# PONTIAC

## Service Craftsman News

No. 8 S-286

# NEW SHIMMING PROCEDURE RELEASED FOR STRATO-FLIGHT FLEX PLATE

Fig. 1 Measuring Clearance Between Flywheel and Flex Plate

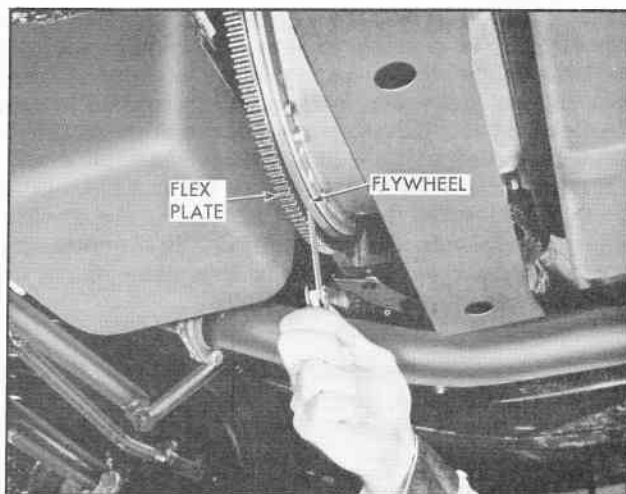
Any time a transmission is being installed in the field, shims should be installed at each flex plate mounting pad to reduce the draw to .013" to .024". This applies to new transmissions and those that are being replaced after repairs. Install transmission and shims as follows:

1. Proceed according to steps 1-8 under "INSTALLATION OF TRANSMISSION" on page 104 of Part I in the 1956 Hydra-Matic Manual. Be especially careful to check as outlined in step 4 to see that the flywheel pilot has properly entered the end of the crankshaft.
2. Rotate flywheel to position one flex plate mounting pad down. Push forward lightly on flywheel to seat it against crankshaft. Measure clearance between pad on flex plate and flywheel, using feeler gauges (Fig. 1) insert shims part no. 523087 (approximately .011") and part no. 523088 (ap-

proximately .030") to reduce this to .013" - .024" clearance (Fig. 2). Coat shims with petrolatum so they will remain in position. Do not install nut until shims have been installed at each attaching pad since it will cock the assembly giving a false measurement of clearance at the other pads.

Fig. 3 Testing TV Pressure

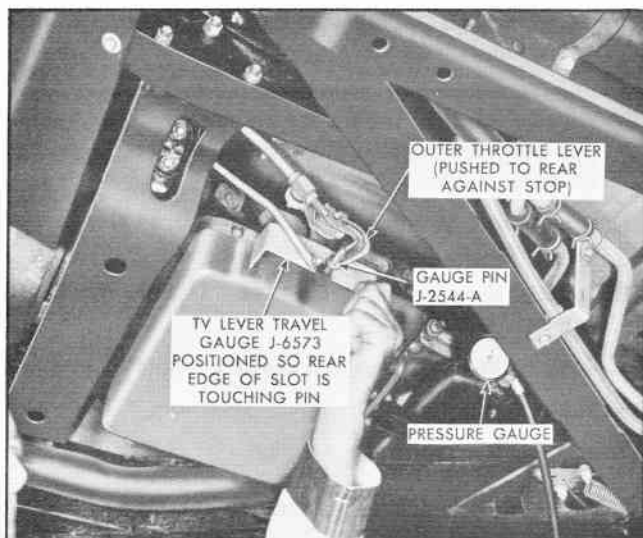
5. Insert gauge pin J-2544-A in TV lever and move TV lever to rearmost position.
6. While holding lever in this position, place TV lever travel gauge J-6573 against side of transmission pan so that gauge pin in lever is touching rear of slot (Fig. 3).

7. Holding gauge J-6573 securely against side of pan, move TV lever forward until gauge pin in lever touches front of slot and read TV pressure on pressure gauge. Pressure should be 20-22 lbs.

8. If pressure is not correct, stop engine, drain fluid from transmission and remove pan. Move TV stop pin on control valve rearward to reduce TV pressure or forward to increase TV pressure. Moving the pin .030" will change TV pressure about 5 lbs.

Fig. 4 Air Conditioning Rancostat

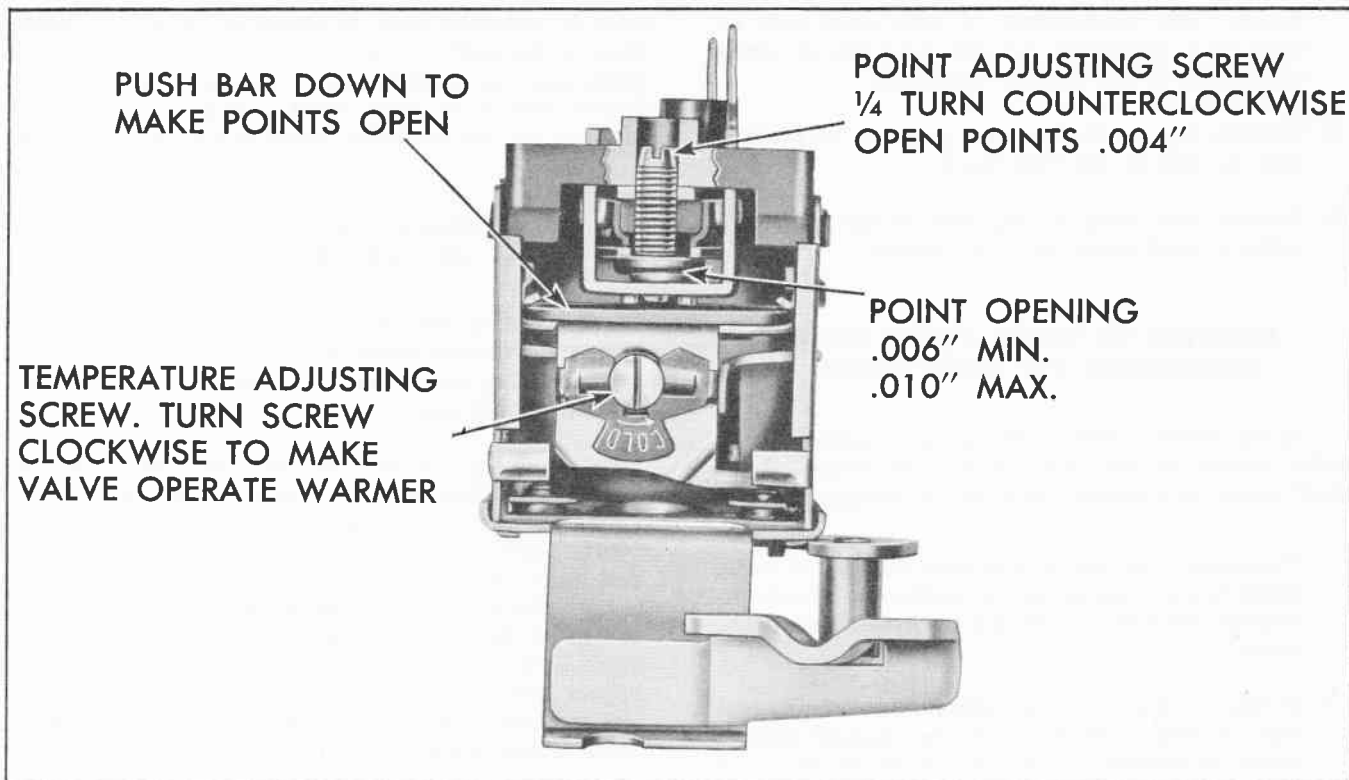
1. Check for heat leak at heater.
2. Perform operational check, making sure suction pressures, discharge pressures, and nozzle temperatures are all in accordance with the specifications on Page 49 of the 1956 Air Conditioning Manual.
3. If all pressures and temperatures are within specifications, turn engine off and remove the thermostat and air distributor as an assembly for the following checks:
  - a. Lift the pressed paper door on the thermostat.
  - b. Move the cam lever at the bottom of the rancostat (thermostat) towards you as you face the end of the rancostat just exposed by removing the door.
  - c. Pressing down on the plastic bar, which is in the center of the opening, Fig. 4, observe the distance that the rancostat points open. This

distance should be a minimum of .006" and should not exceed .010". If points appear to be burned or oxidized, very light filing is suggested. (Use a thin or very fine riffler file.) If it is necessary to adjust these points, use a screw driver and turn the screw on the upper portion of the rancostat the necessary distance to give you the proper gap (1/4 turn of this screw counterclockwise will increase the point opening .004"). As the top of the screw is cemented, it will require a screw driver of the right size and properly sharpened to effectively turn it, otherwise the head of the screw will be damaged.

If the owner advises that air coming from the nozzles turned warm in a relatively short period of time (1/2 hour country driving or from 15 to 20 minutes city driving), then turn the temperature adjusting screw 1/2 turn clockwise **OPPOSITE TO THE DIRECTION INDICATED BY THE ARROW**.

If the owner advises that an hour's driving was required to cause freeze-up, then move the temperature adjusting screw 1/4 turn clockwise.

Fig. 5 New Type Striker Sleeve

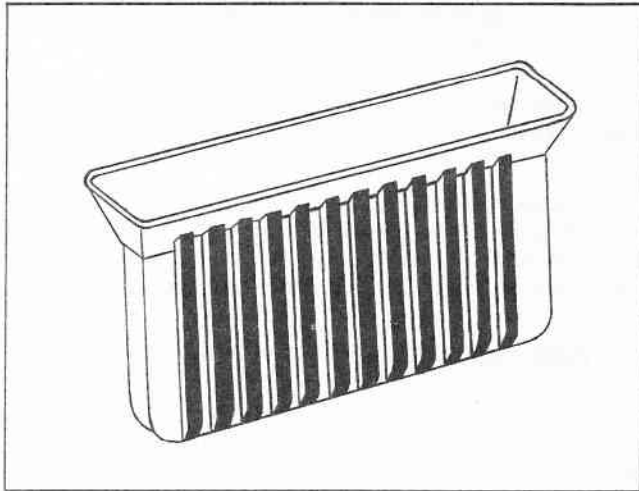
To eliminate squeaks between the side roof rail mechanical sealing strip striker sleeve and the door ventilator assembly on Catalina Coupes, a new striker sleeve has been released to production. This new striker sleeve incorporates serrations on the contacting surface (Fig. 5). The new striker sleeve is available for field use under Part Number 4690492.

Fig. 6 Reworked Striker Sleeve

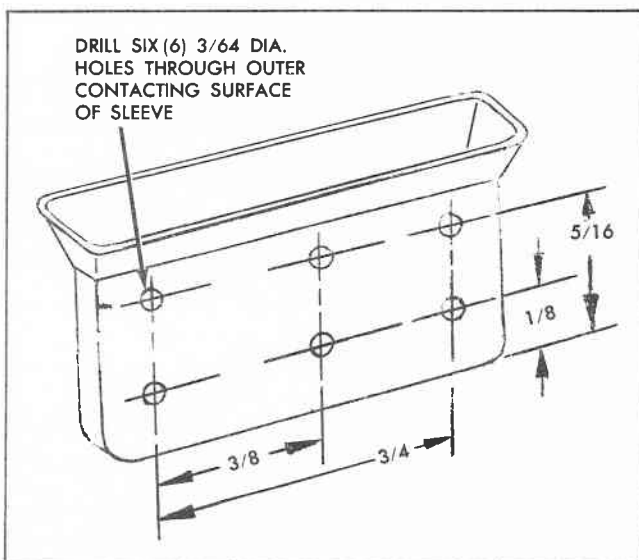
If the new striker sleeve is not readily available, the old striker sleeve may be reworked as shown in Fig. 6. The reworked striker sleeve must be lubricated on the inside with Lubriplate lubricant before installation. This will allow lubricant to fill holes in striker sleeve when the striker is installed.
